Table 4. Fork Installation Distance

Figure 3. Recall Kit 0190

Figure 1.

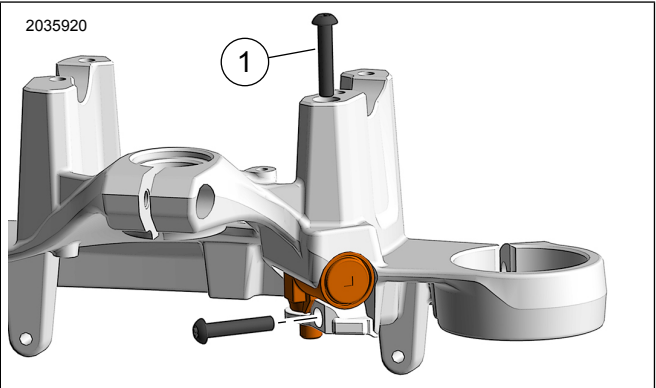
- a. See Figure 1. Use **new** screw (Part No. 10200925) supplied in recall kit for installation of fork lock to **new** upper triple tree.

Figure 2. Front Fork Mount (typical)

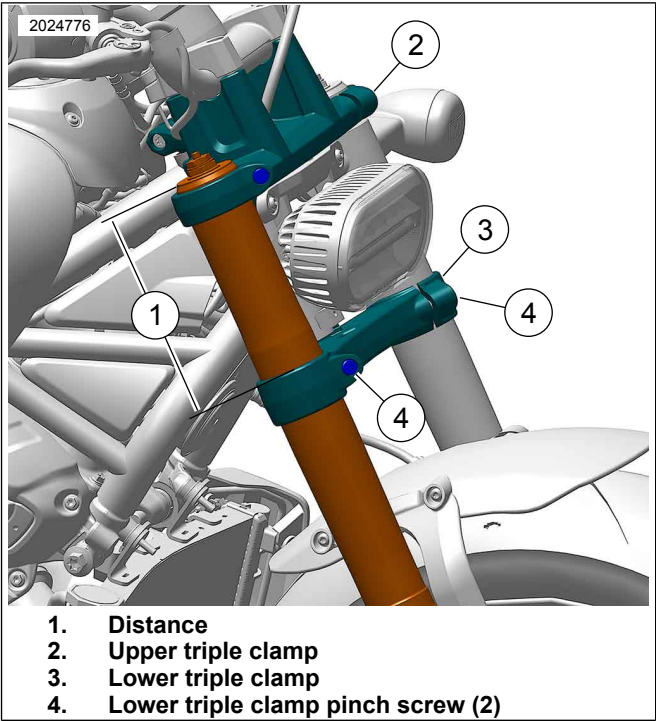
2. With the OE upper triple clamp (2) removed, set fork height. Refer to Table 4.
 - a. See Figure 2. Measure distance (1) from top of fork tube to top of lower triple clamp (3).

- b. If distance is not within specification, set fork distance.
 - c. Loosen lower triple clamp (3) pinch screw (4).
 - d. Adjust as needed. Tighten screw (4).
Torque: 33 N·m (24 ft-lbs)

- e. Repeat procedure on opposite side.
3. If distance is within specification, adjust lower triple clamp pinch screws (4) to **new torque**:
 - a. Leave lower triple clamp (3) in its current location.

- b. Loosen screws (4) individually 90 degrees.
 - c. Tighten screws (4).
Torque: 33 N·m (24 ft-lbs)
4. See Figure 3. Install **new** upper triple clamp (3) from recall kit. See service manual.

Model	Distance
RH1250S	177.8 ± 1.5 mm (7 ± 0.06 in)

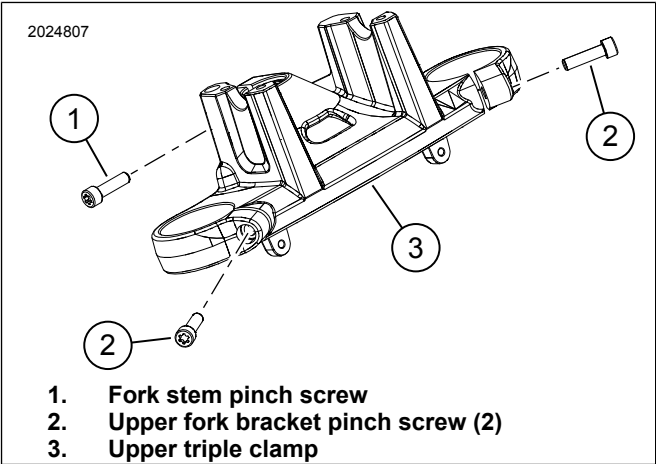
5. See Figure 3. Install screws (1, 2) from recall kit and tighten.
Torque: 33 N·m (24 ft-lbs)
6. Install remaining vehicle components that were removed to gain access to upper triple clamp. See service manual.
